12/09/20	Deleted Reconstruction Callout R6. Added Reconstruction Callout R5.
DATE	REVISION
STATE OF HAWAII DEPARTMENT OF TRANSPORTATION HIGHWAYS DIVISION	
ROADWAY PLAN	
Vineyard Blvd & Queen Emma St	
ADDITIVE ALTERNATE #1	
Traffic Signal Modernization, Oahu, Phase 1	
Federal-Aid Project No. STP-0300(163)R	
Scale: 1"=10'	Date: Oct. 2020
SHEET No. R-19 OF 81 SHEETS

Traffic Signal Modernization, Oahu, Phase 1

Federal-Aid Project No. STP-0300(163)R

CURB RAMP PLAN
Kalanianaʻole Hwy & Kalaniki St

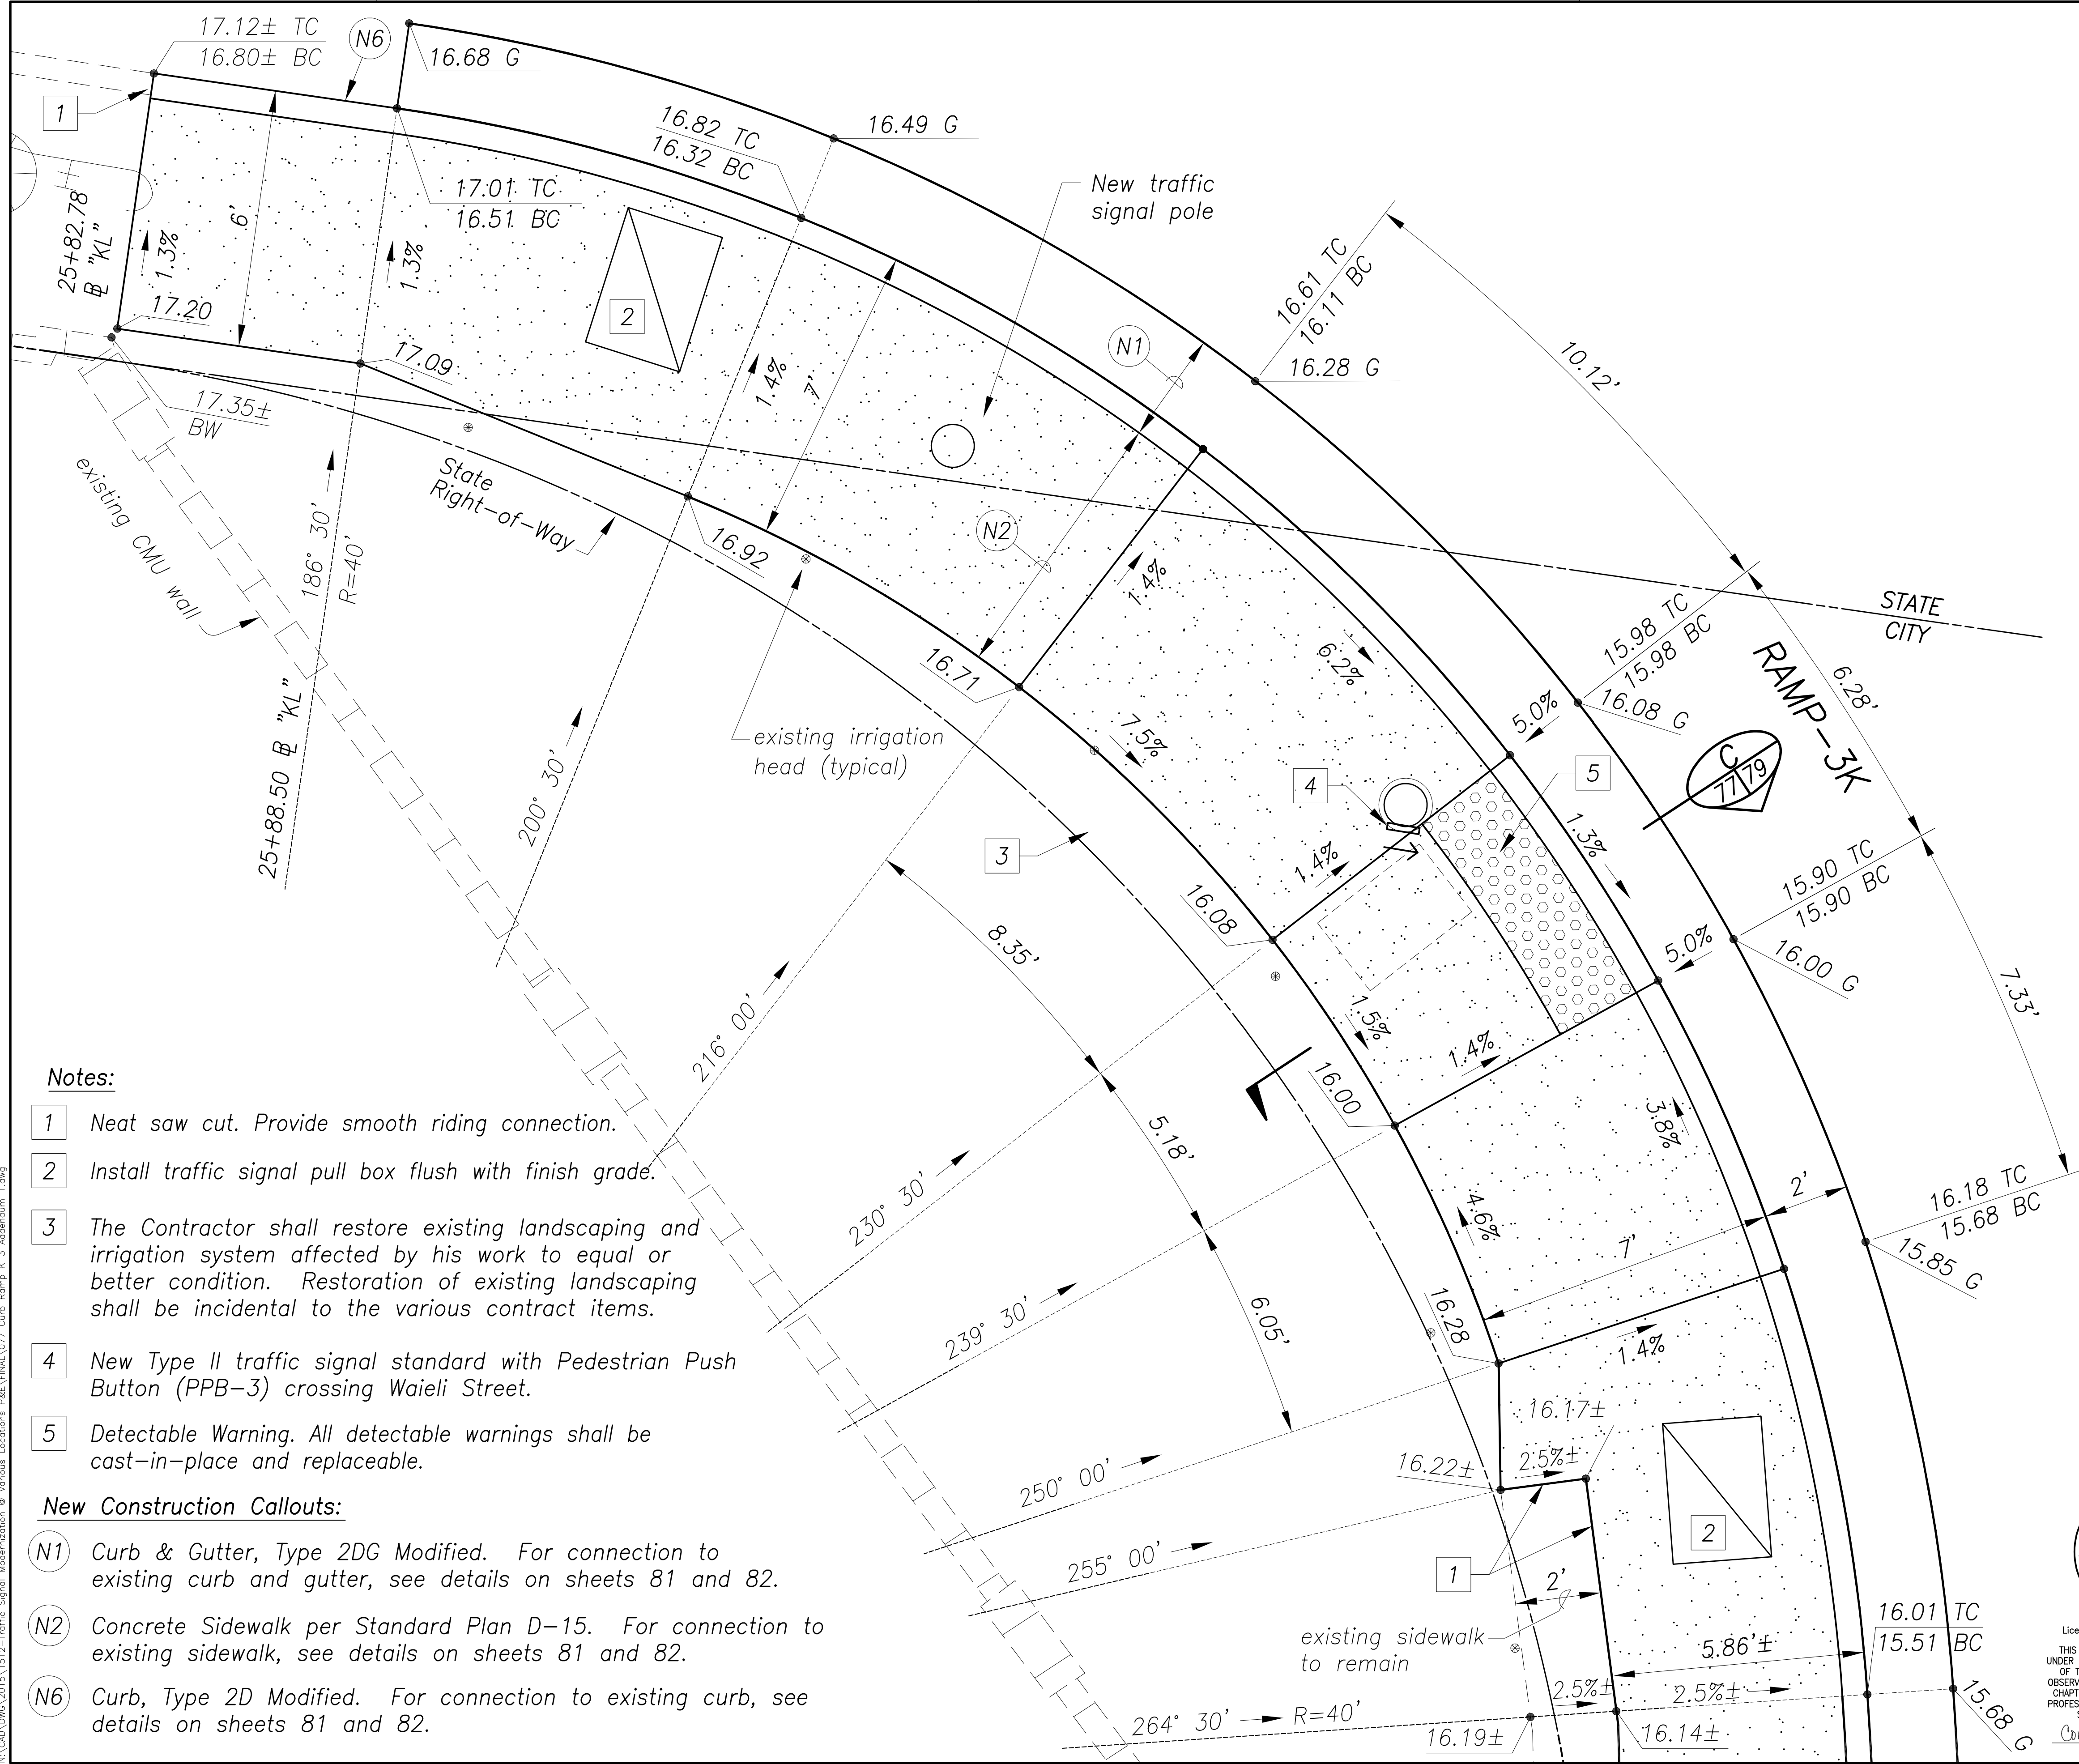
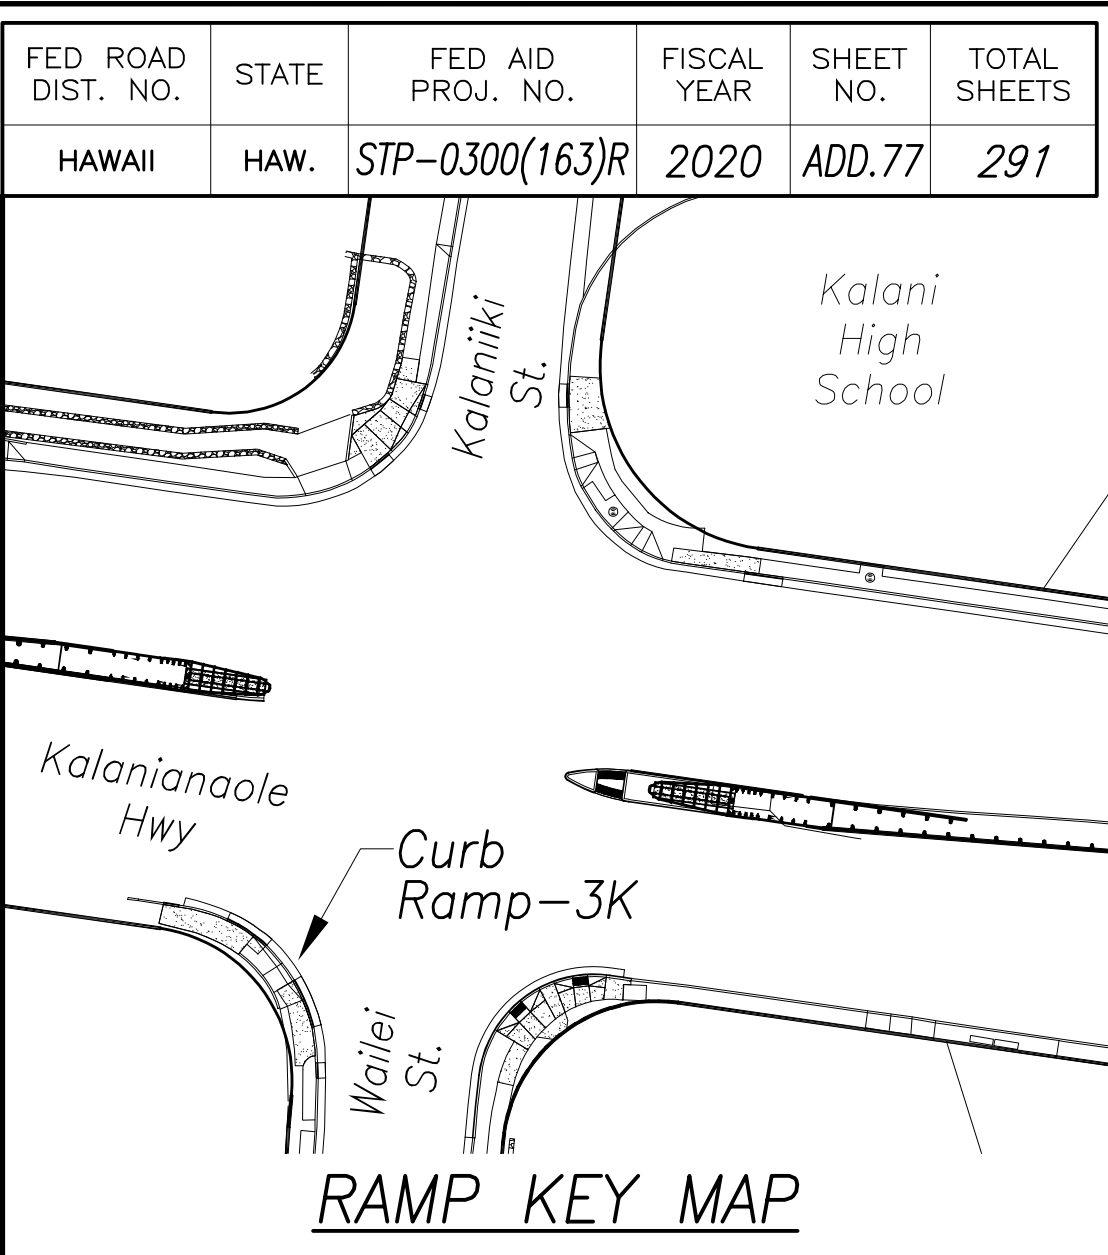
12/09/20	Added Note 3.
DATE	REVISION

- Notes:**
- 1 Neat saw cut. Provide smooth riding connection.
 - 2 Install traffic signal pull box flush with finish grade.
 - 3 The Contractor shall restore existing landscaping and irrigation system affected by his work to equal or better condition. Restoration of existing landscaping shall be incidental to the various contract items.
 - 4 New Type II traffic signal standard with Pedestrian Push Button (PPB-3) crossing Waieli Street.
 - 5 Detectable Warning. All detectable warnings shall be cast-in-place and replaceable.
- New Construction Callouts:**
- N1 Curb & Gutter, Type 2DG Modified. For connection to existing curb and gutter, see details on sheets 81 and 82.
 - N2 Concrete Sidewalk per Standard Plan D-15. For connection to existing sidewalk, see details on sheets 81 and 82.
 - N6 Curb, Type 2D Modified. For connection to existing curb, see details on sheets 81 and 82.

EXISTING SIGNAL PLAN
Kahuapaani St & Ulune St

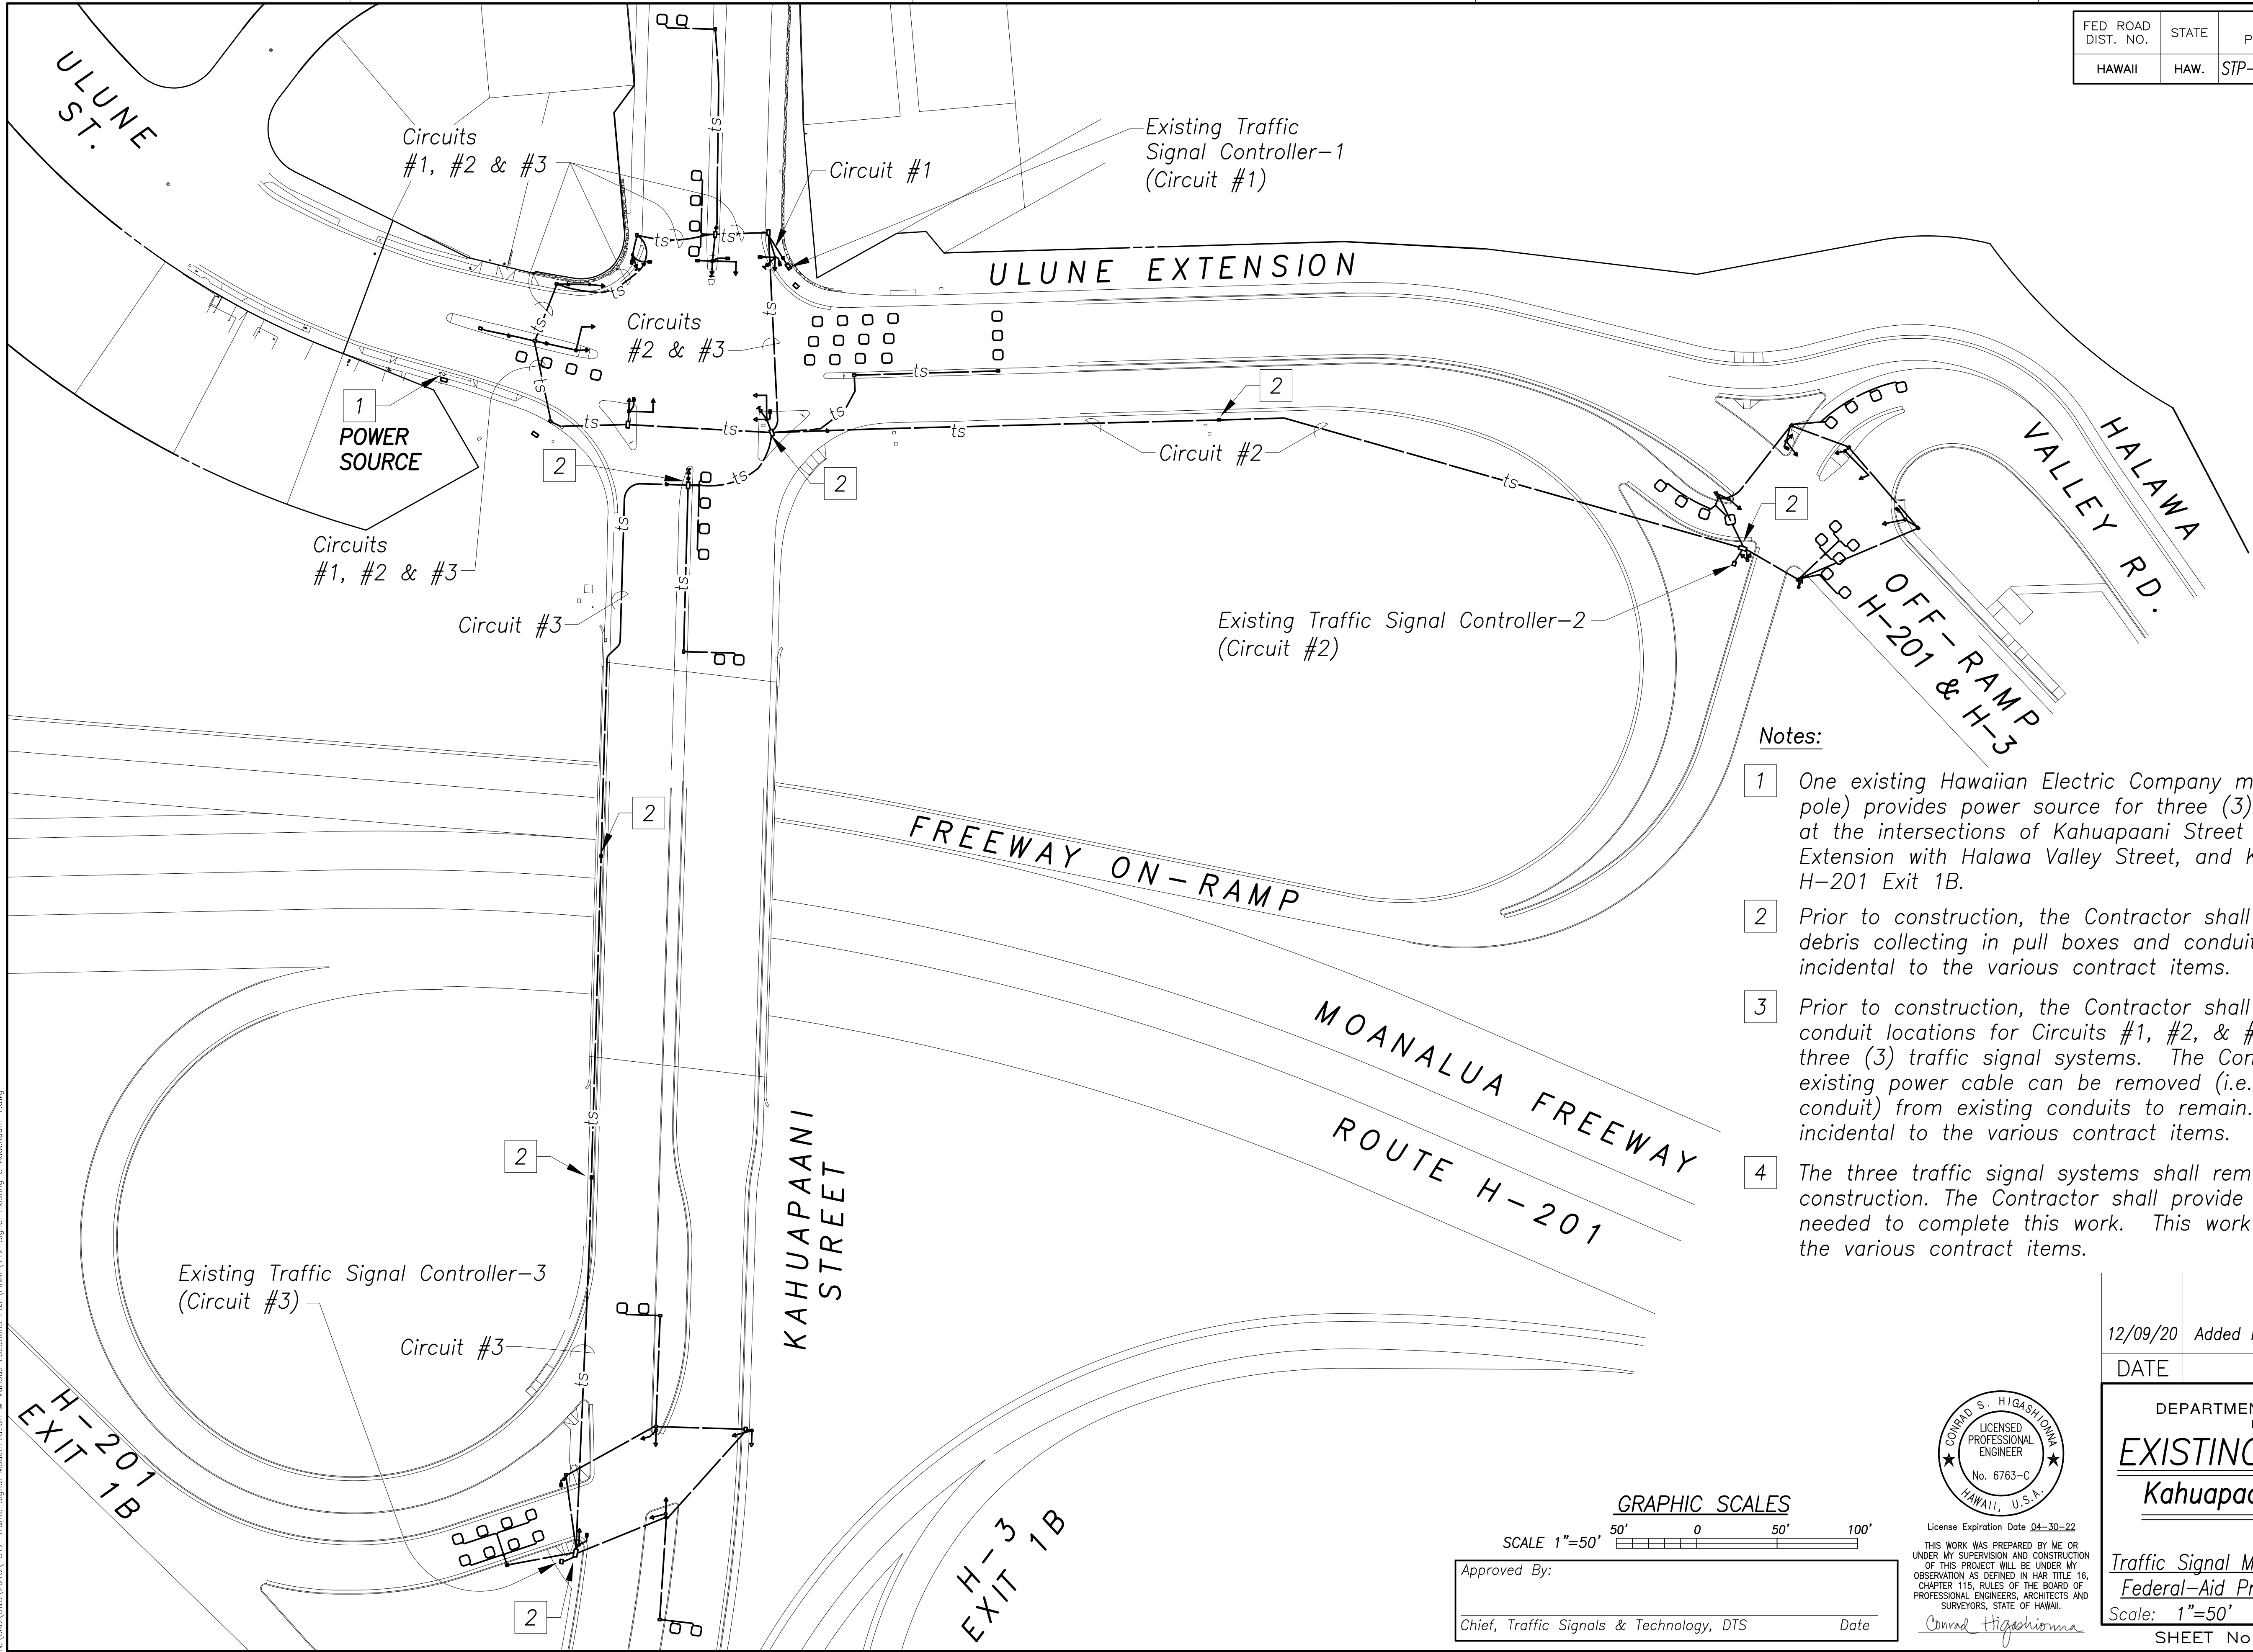
12/09/20	Added Note 4.
DATE	REVISION

- 4 The three traffic signal systems shall remain operational during construction. The Contractor shall provide temporary power as needed to complete this work. This work shall be incidental to the various contract items.
